Hi-Fi Products
Service Bulletin

Model: CDP-C20/C30/C40/C50/C50M/C70/C7ESD **No. 78**

Subject: Part Number Missing - Disc Table Frame **Date:** July 25, 1989

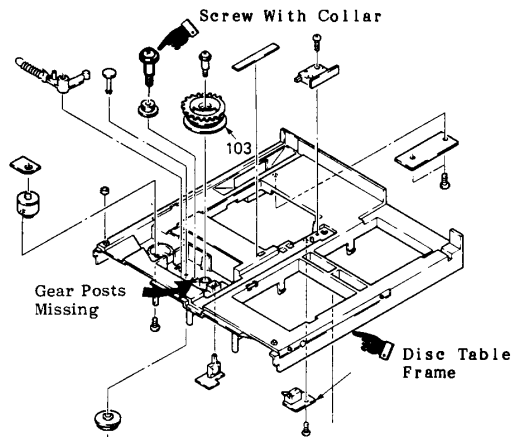
The part number for the Disc Table Frame, shown in the diagram below, is not referenced in the service manual.

The new frame is missing one of the gear posts. A self-tapping screw with collar must be installed as shown in diagram.

Description	Part Number
Disc Table Frame	4-924-407-06
Screw With Collar	4-926-320-01
